# Untapped Aquifers
Cedar Valley Drainage Basin

H. Roice Nelson, Jr. & Gary Farnsworth Player - Cedar City Council & Candidates Field Trip

10 August 2019

From Kelly Crane <kcrane@ensignutah.com>
Subject **Summaries from evaluations**   11:00 AM
To Me <rnelson@walden3d.com>, Gary Player
Cc Paul Monroe

Frank Nichols Water Opportunity

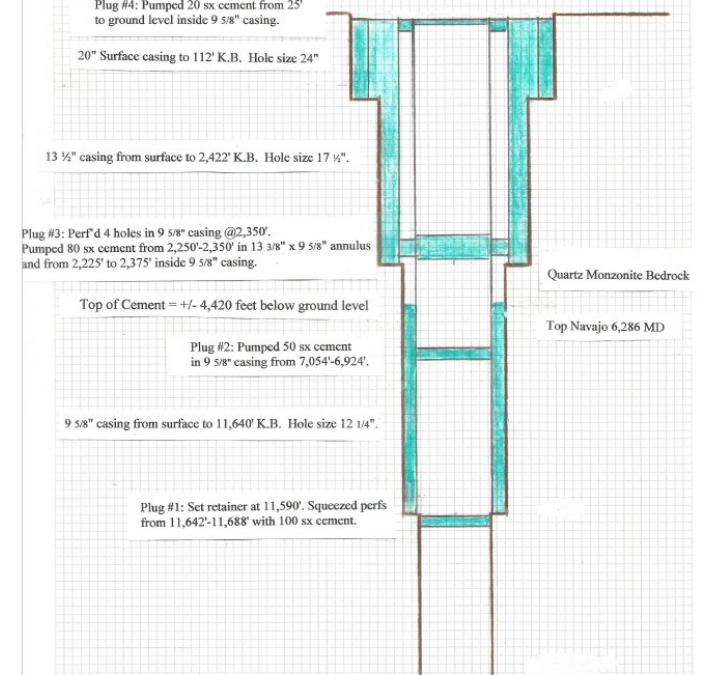
Notes on Arco Well Proposal from CICWCD Geology Advisors (Player/Nelson comments):
- The fracturing within this is only on the very surface of these formations (outcrops disagree) and the likelihood of large water volumes within them is very slim (**incorrect?**) and if a large volume of water was found it would most likely be finite in nature (12" annual recharge) and would deplete quickly as the wells proved for the Iron Mines just south west of the proposed well.

- The individual laccoliths are formed individually and are not equally fractured. The same conclusion cannot be drawn between the granite structures in the Cedar Valley and the well that the Church drilled in the New Harmony area within the ash creek drainage. That well is located at the confluence of multiple fracture systems and has the drainage from the north end of the Pine Valley mountains (there are also multiple fracture zones in the Iron Springs Gap).

- This project as proposed would not be a new source of water and would be quite expensive to develop since the water would be pumped from depths approximately 2,500 feet deep (hydrostatic level expected to be only a few hundred feet deep). In addition to having challenges of pumping from such depths the well casing is small and you would not be able to pump more than 500 gpm from this size of well (13.5" at pump 9.5" where perforated, rates determined by testing).

- From a water rights perspective this water would come from existing water rights within the Beryl Enterprise basin. This would not be considered as a new appropriation of water since the basin is closed and has been for some time. (still new water for Beryl, well is on the boundary of the two basins, the water could be diverted either way, as CIWCD is currently pumping water further to the west. The key is to test for a new source of water which has a different age and a different hydrostatic pressure than any water in the Cedar Valley fill aquifer or the Beryl Valley aquifer).

Age of Water and Harmony Hills

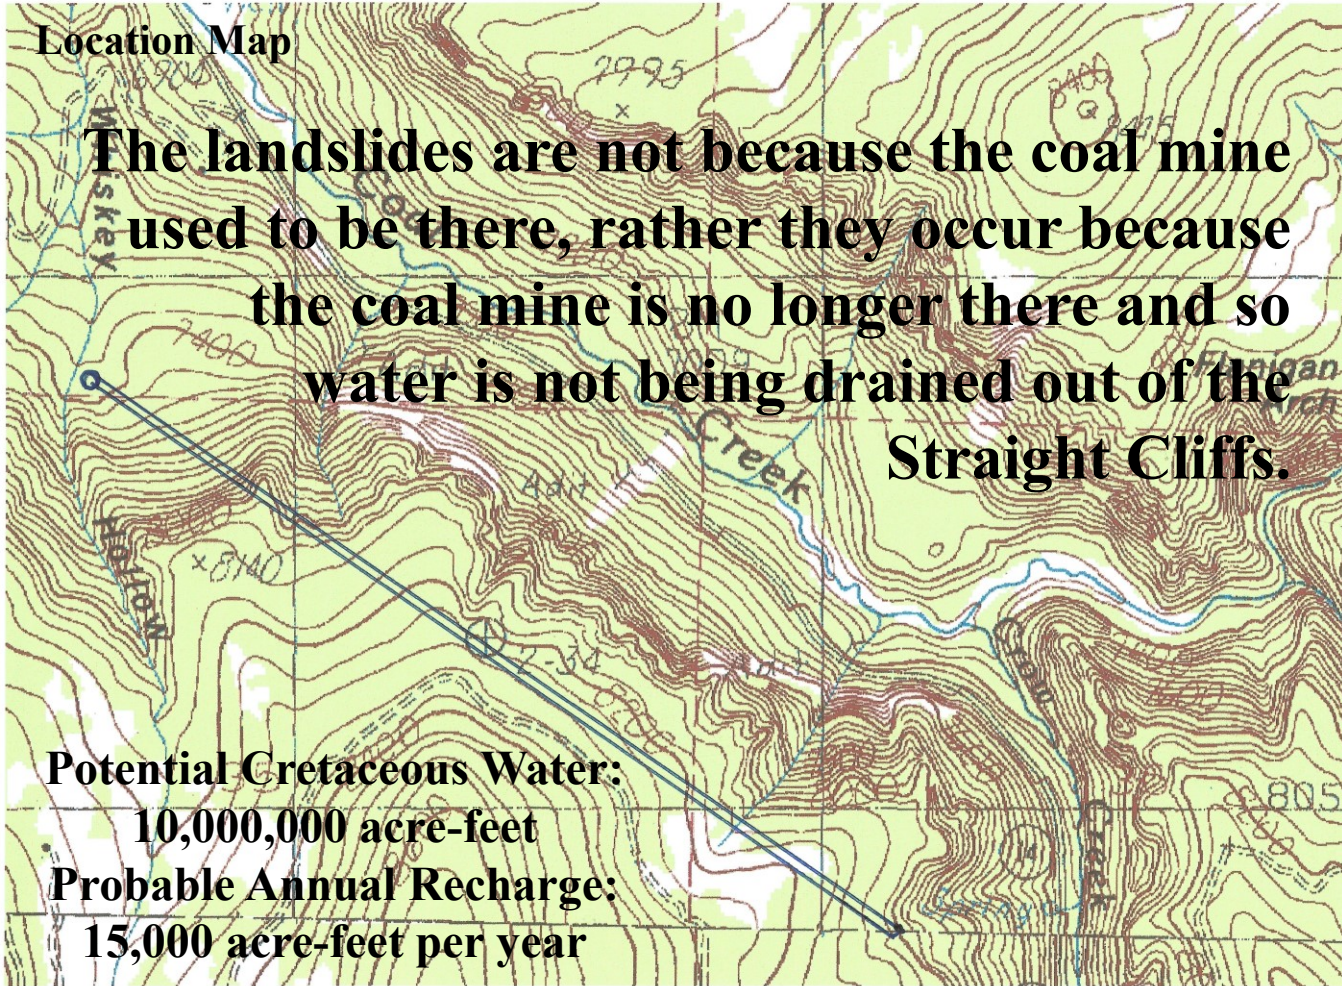
Notes on Quichapa Creek well Re-Entry from CICWCD Geology Advisors (Player/Nelson comments):
- This project will affect the overall system much the same as the Arco well re entry project. (It is proposed to test the Quartz Monzonite, and not in the Beryl Valley Aquifer Water Rights Area).

- The supposition that additional water is existent at these lower depths is incorrect. (Based on what? Science or conjecture?) The water from these lower depths would be connected to the existing aquifer that we currently draw water from (Check the age of the water). The infiltration rates discussed in the Fractured Quartz Monzonite Aquifer are not realistic and are an over simplified method of determining recharge. (Nelson has worked several oil & gas fields tied to natural fracture permeability. The issue is the water moves a long distance, the oil and gas cones out, the water comes and comes and comes.).

- The Quartz Monzonite is formed from the laccoliths that are essentially big bulges of granite that have surfaced in a bulge in different areas where the soils above allowed. (As it cools it fractures, creating a reservoir.).

- The fracturing within this is only on the very surface of these formations (**check outcrops**) and the likelihood of large water volumes within them is very slim (check outcrops) and if a large volume of water was found it would most likely be finite in nature (review Ghawar, Ciudad del Carmen, Maui, and other fractured reservoirs) and would deplete quickly as the wells proved for the Iron Mines just south west of the proposed well (needs test).

- The individual laccoliths are formed individually and are not equally fractured. The same conclusion cannot be drawn between the granite structures in the Cedar Valley and the well that the Church drilled in the New Harmony area within the ash creek drainage. That well is located at the confluence of multiple fracture systems and has the drainage from the north end of the Pine Valley mountains. In addition to having challenges of pumping from such depths the well casing is small and you would not be able to pump more than 500 gpm from this size of well. (since comments are repeated, see comments above).

- From a water rights perspective this water would come from existing water rights within the Cedar basin. This would not be considered as a new appropriation of water since the basin is closed and has been for some time. (If it is demonstrated to be a different age and to have a different hydrostatic water pressure, it can be proven to be a new source of water.).
